**Re: 39 LACEY ROAD, CARSELDINE  
INFORMATION REQUEST RESPONSE**

This letter has been prepared by PTT, on behalf of The Hamptons (Qld) Pty Ltd, in response to the traffic engineering related issues raised in Brisbane City Council's (BCC) Information Request (IR), dated 14 July 2025. The development application (Reference: A006743933) seeks approval for a development permit for a material change of use for an extension to an existing multiple dwelling, resulting in three additional dwellings, on land located at 39 Lacey Road, Carseldine.

**1 GENERAL ARRANGEMENT GROUND FLOOR PLAN**  
Scale: 1:1,250

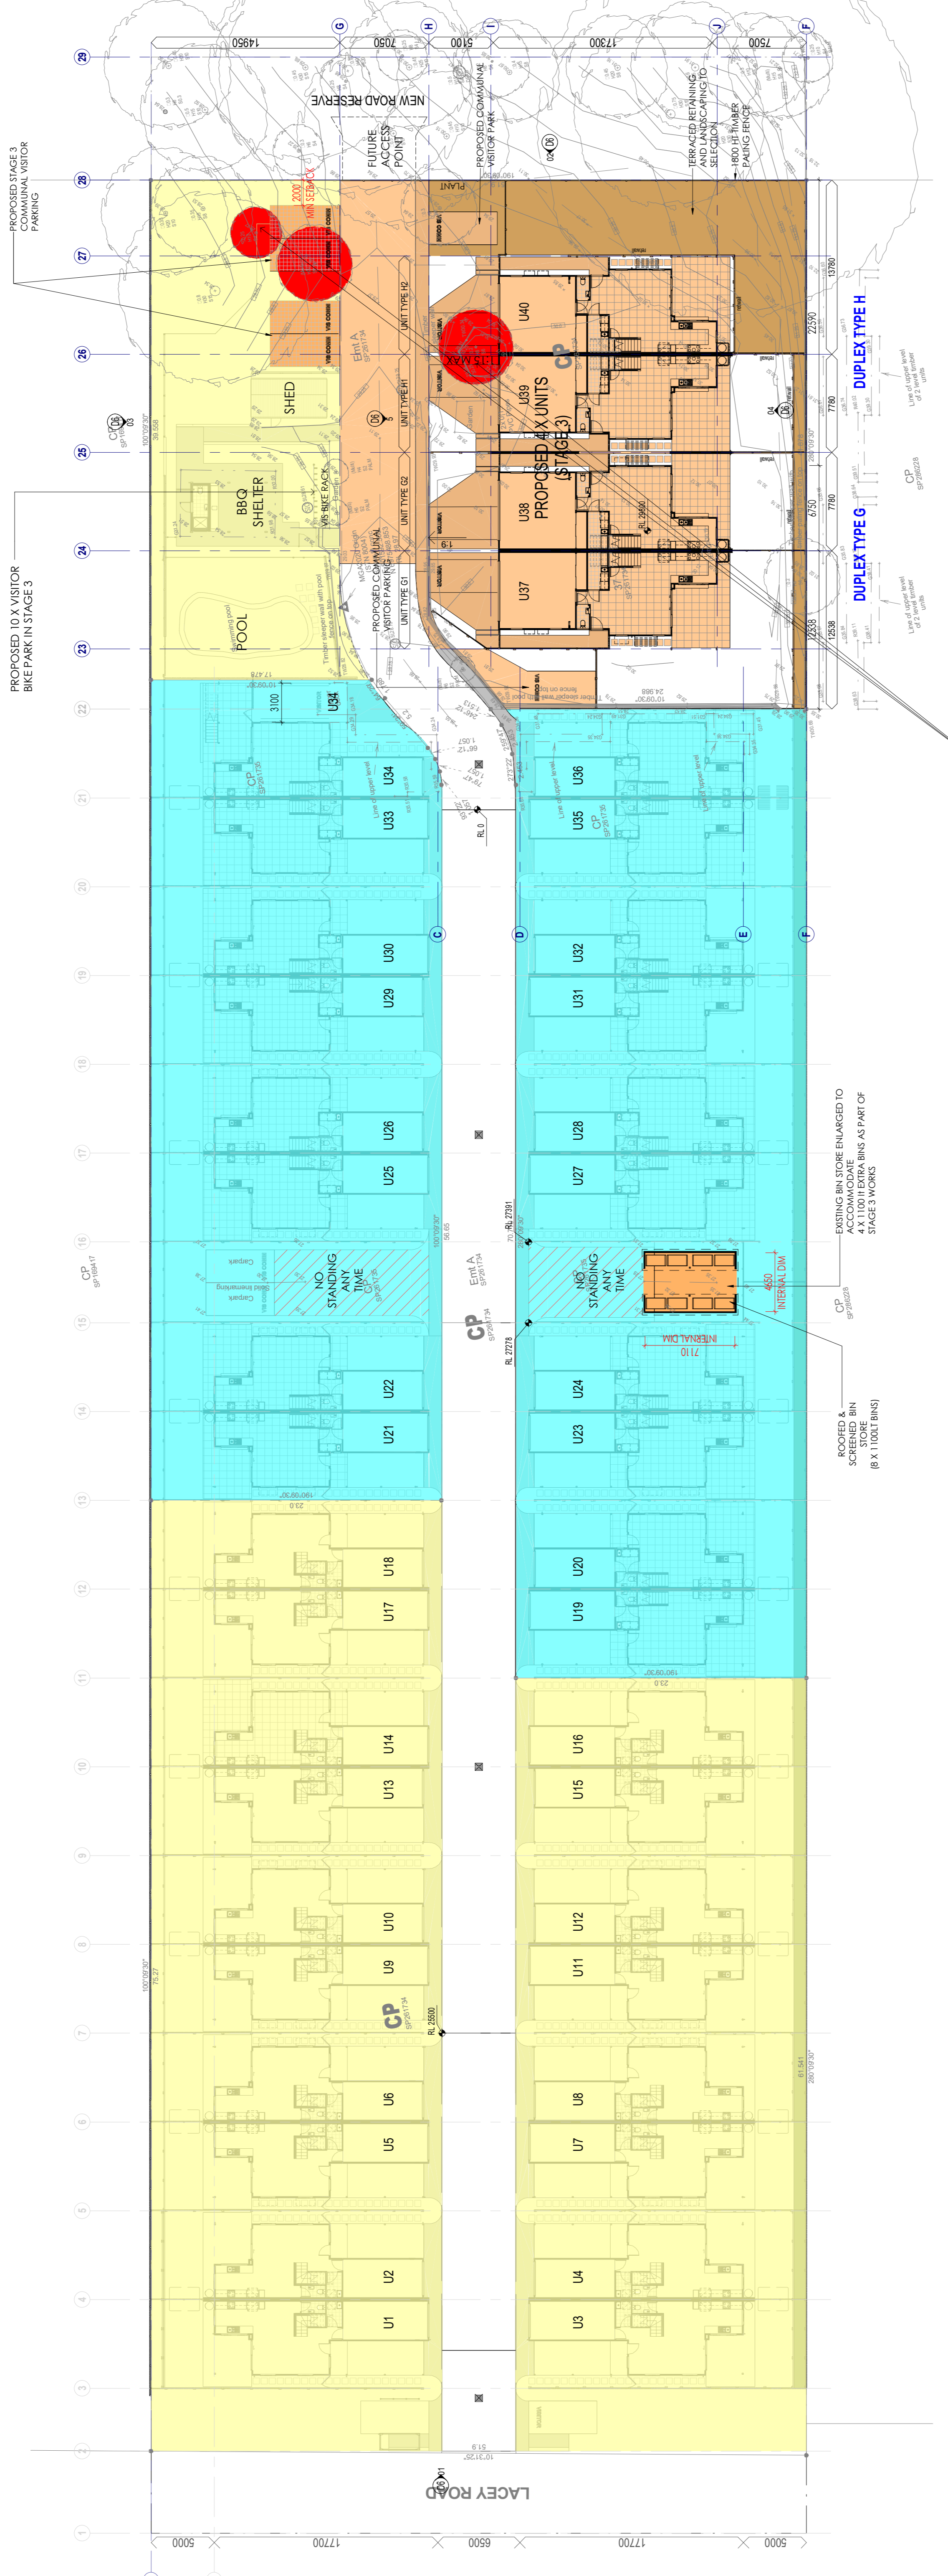
*"The submitted Area Summary & Exclusive Use Areas plan indicates the change application is increasing the number of exclusive private parking spaces and reducing the existing number of visitor spaces for the overall development. It is noted that in the original approval the parking spaces proposed to be located at the road frontage, were not accepted and the plans marked in red to replaced them with landscaping. In addition, the layout of visitors' spaces in the original approval are presented differently to what is now shown on proposed drawing number DA-01 dated 21.02.2025 page D10 of 11. The layout as shown as existing does not align with and is not consistent with the original approval A003575073. The total spaces as per the original approval conditions requires 73 spaces including (36 spaces exclusive use and 37 spaces for visitors) and 37 bicycle spaces located within each unit inside the garages.*

- (a) *The number of spaces within the parking summary as shown on DA-01-page D10 of 11, does not align with the number of spaces approved (as per the approved conditions and approved plans) and proposes a combined 94 number of spaces. Submit additional information accurately describing the number of spaces approved (existing) and the number of spaces when the changes have been completed. Clearly show any existing spaces that will be removed and how or if they will be replaced.*

- (b) *The parking for the additional units (only), may meet the proposed number of spaces. However, the overall changes redistribute and diminish the number of visitor spaces significantly as the whole site is proposed to amended (for parking). The current standard required of the overall development, seeks 110 spaces (including 10 visitor spaces) and 10 bicycles spaces for visitors. The proposal only allows for 94 spaces in total, with no provision for bicycle spaces for visitors. It also proposes to locate visitor spaces at the road frontage, when this was not accepted under the original approval and has been marked in red on the approved plans for landscaping. The proposed changes to the development represent a parking short fall of more than 16 spaces.*

- (i) *Provide a traffic report endorsed by an RPEQ (a minor statement or letter is likely sufficient) to demonstrate that the proposal complies with the TAPS PSP. Any performance outcome is to be justified by the RPEQ (ie the short fall in parking, a review of the breakdown of exclusive use and visitor parking, including provision for bikes in the overall development)*

The proposed plan of development (attached) incorporates two resident car parking spaces per unit in a lock-up garage (ie 80 resident spaces in total) and 10 visitor car parking spaces, not counting the four exclusive use "visitor" spaces in front of Units 37-40, located as follows:

- two visitor spaces adjacent to the lacey Road driveway
- two visitor spaces between units 22 and 25
- one visitor space east of Unit 36
- four visitor spaces on the northern side of the internal road leading to the eastern driveway
- one visitor space on the southern side of the internal road leading to the eastern driveway

The proposed plan of development (attached) incorporates a wall mounted bike rack within the lock-up garage of each the new units and 10 visitor bicycle parking spaces in front of the BBQ area. Thus, the proposal is compliant with respect to the provision of bicycle parking spaces for the new units and visitor bicycle parking across the whole development.
